# Flood Risk and Surface Water Assessment Rev3

St James C of E Primary School  
Clitheroe

17 September 2021

A Flood Risk and Surface Water Assessment (Rev2) was prepared to support the planning application for the proposed redevelopment of St James' C of E Primary School, Clitheroe.

**Appendix I -** Top of Bank Plan

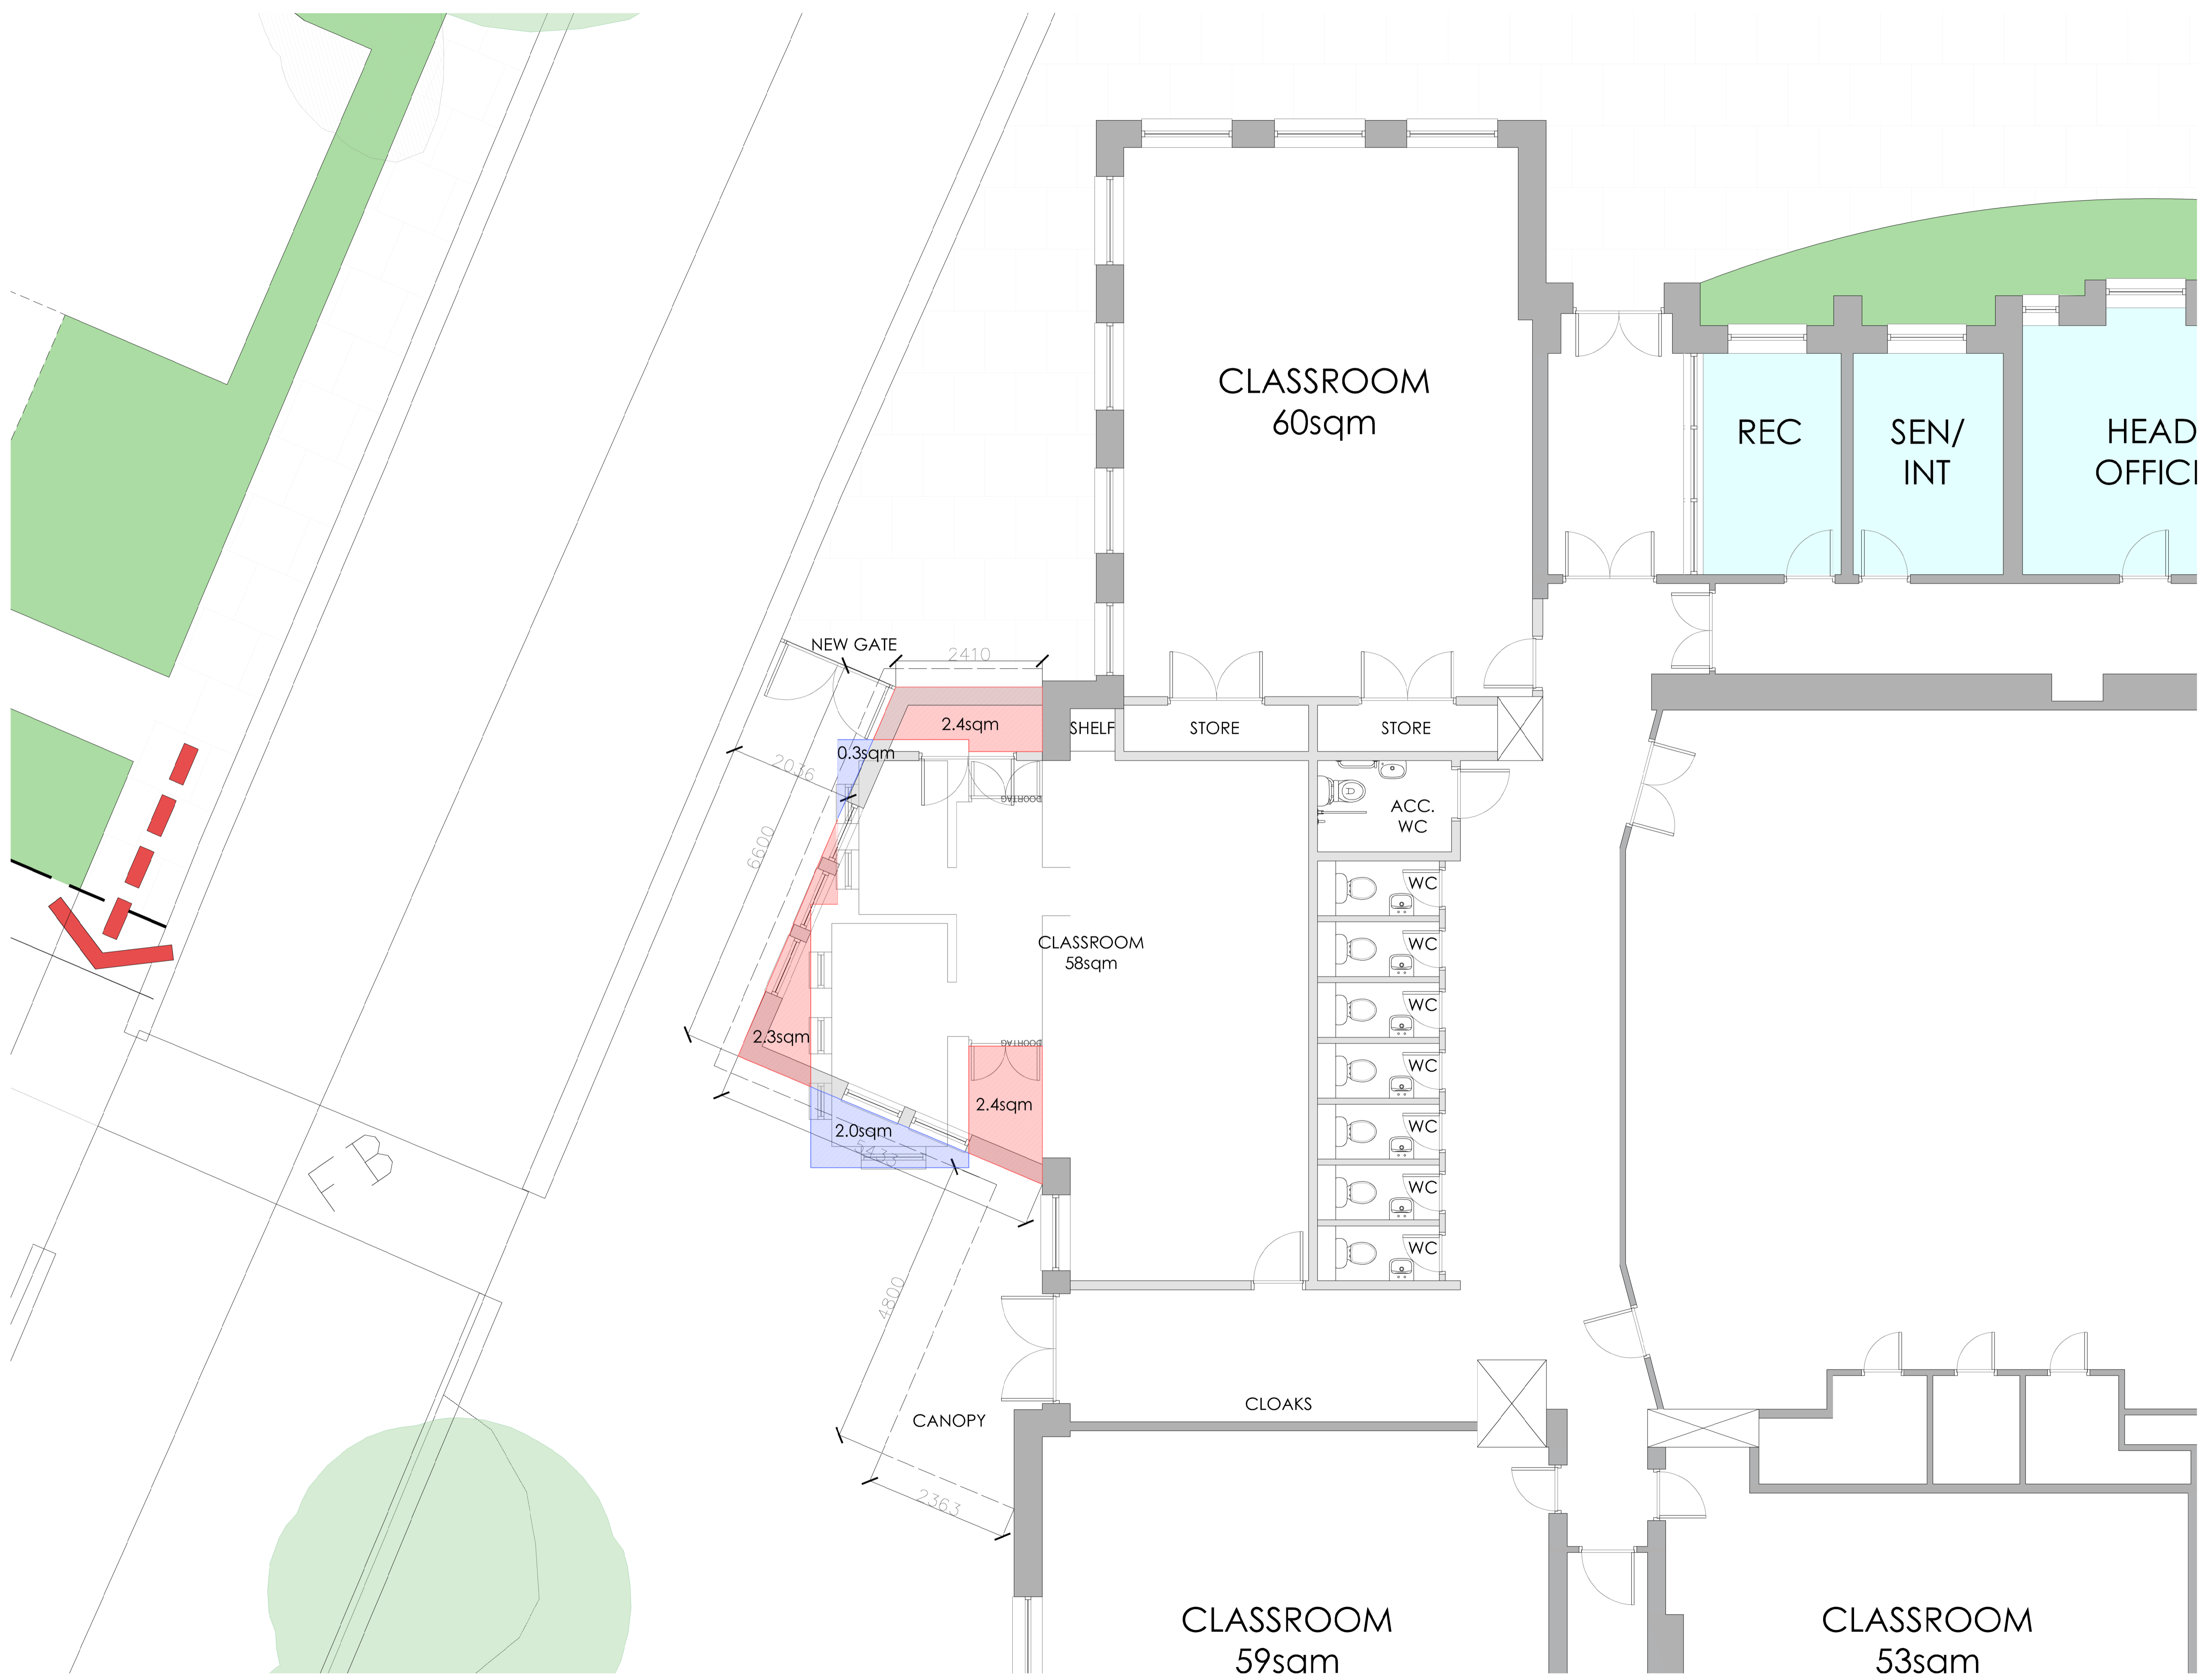
*Please submit a plan clearly showing 8metres from top of bank and 8metres from the flood defences. Dimensions must also be shown at pinch points.*

- At present, the distance the proposed development is away from the top of the bank of the watercourse and from the flood defences is unclear. Please submit a plan clearly showing 8metres from top of bank and 8metres from the flood defences. Dimensions must also be shown at pinch points.

Cassidy Ashton Architects has prepared a plan ([Appendix I](#)) which shows the school building as existing with the proposed extension overlaid. Portions of the existing building are located within 8m of the top of the bank, and at the nearest point is approximately 2m away from the top of the bank.
